**HOLTEC**  
INTERNATIONAL

Subject: NRC 10 CFR 72 Certificate of Compliance No. 1008, TAC L22019  
License Amendment Request 1008-1

Holtec International hereby submits License Amendment Request (LAR) 1008-1, Revision 0, proposing certain amendments to 10 CFR 72 Certificate of Compliance (CoC) No. 1008 and its supporting Topical Safety Analysis Report for the HI-STAR 100 System. Information describing and justifying the changes requested by this LAR is contained in the attachments listed below. In preparing this amendment request package, we have intentionally included non-mandatory material, such as marked-up and final versions of the CoC, and proposed Topical Safety Analysis Report (TSAR) changes. This non-mandatory information adds to the overall bulk of the submittal, but should greatly facilitate the NRC staff's review effort. A final Revision 11 of the HI-STAR 100 TSAR will be submitted within 90 days of the date of publication of the final rulemaking that issues the CoC amendment.

Attachment 4: Drawing Revision Summary, Revised Holtec Design Drawings, and New Dresden Unit 1 Damaged Fuel Canister and Thoria Rod Canister Drawings.

FIGURE 2.1.6; ILLUSTRATIVE BURNUP AND COOLING TIME FOR DECAY HEAT AND RADIATION SOURCE TERMS

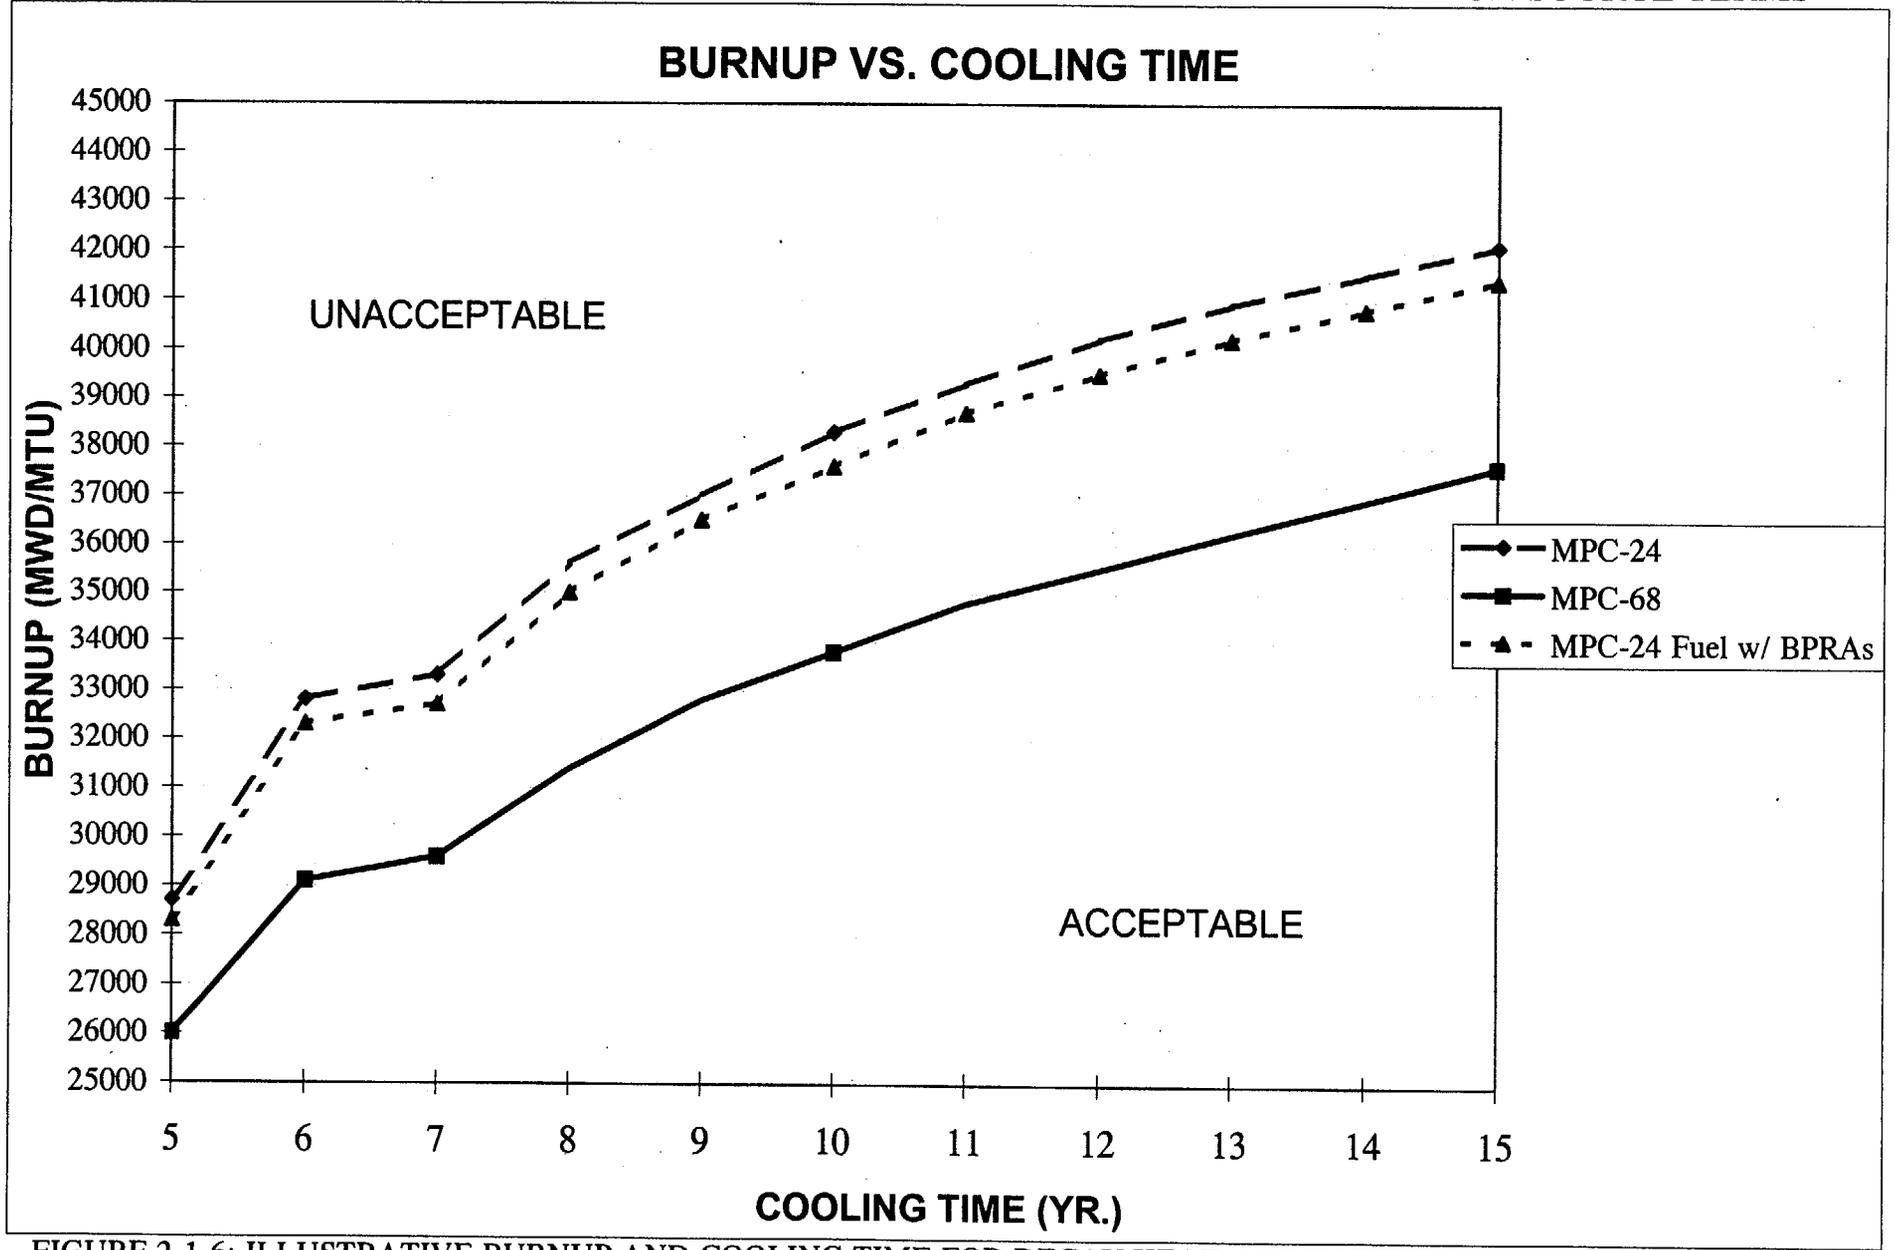
- k. Table 2.1.6 is revised to reflect the addition of fuel assembly array/class 8x8F.
- l. New Table 2.1.12 is added for the Thoria Rod Canister.
- m. Figure 2.1.6 is revised to add a curve for PWR fuel containing BPRAs.

*satisfy the more restrictive burnup and cooling time requirements in Figure 2.1.6. BPRAs and TPDs shall meet the burnup and cooling time requirements specified in the Technical Specification.*

**FIGURE 7.1.3; HI-STAR 100 SYSTEM MPC CLOSURE WELD DETAILS**

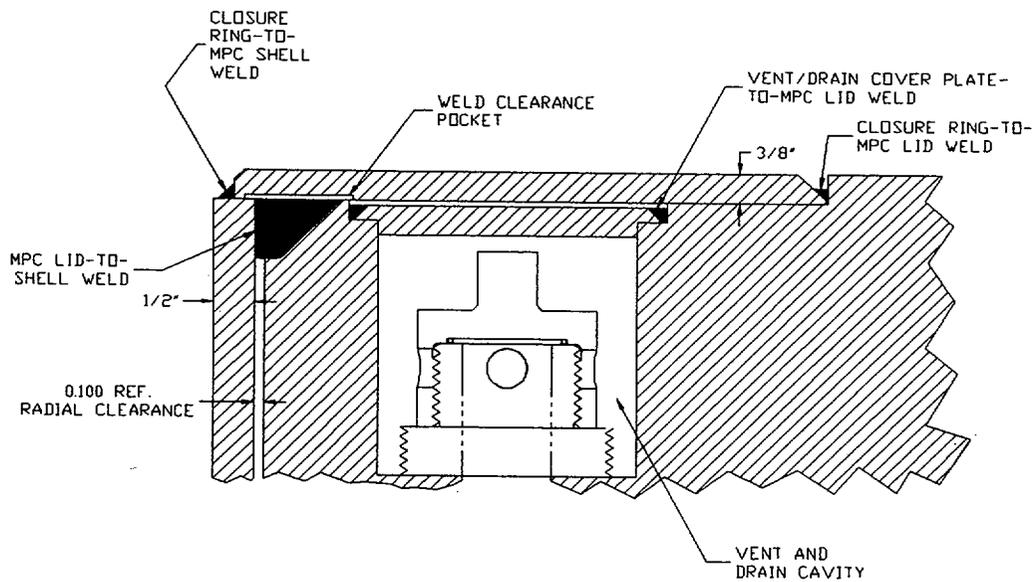
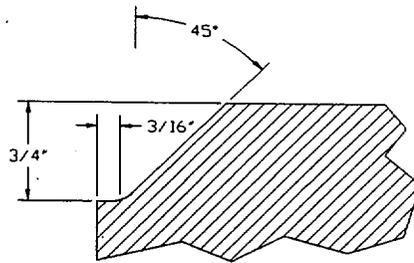
- a. Subsection 7.1.5 is revised to remove reference to Dresden Unit 1 and Humboldt Bay fuel debris.
- b. The design pressures for the mechanical seals shown in Table 7.1.1 is revised from 10,000 psig to 1,000 psig.
- c. Subsection 7.1.2 and 7.1.3 are revised to clarify that root pass PT is only required for multi-pass welds.
- d. Table 7.1.2 is revised to change "full" to "partial" in describing the MPC closure ring segment to closure ring segment radial welds.
- e. Table 7.1.3 is revised to clarify that root pass PT examination is only required for multi-pass welds.
- f. Figure 7.1.3 is revised to remove the call-outs of the closure ring weld size and to correct the size of the MPC lid-to-shell (LTS) weld. A clarifying note is added regarding the LTS weld.

MPC-68 AND MPC-24  
LID-TO-SHELL WELD DETAIL. SEE  
SECTION 1 DRAWINGS FOR DETAILS  
FOR OTHER MPC MODELS.
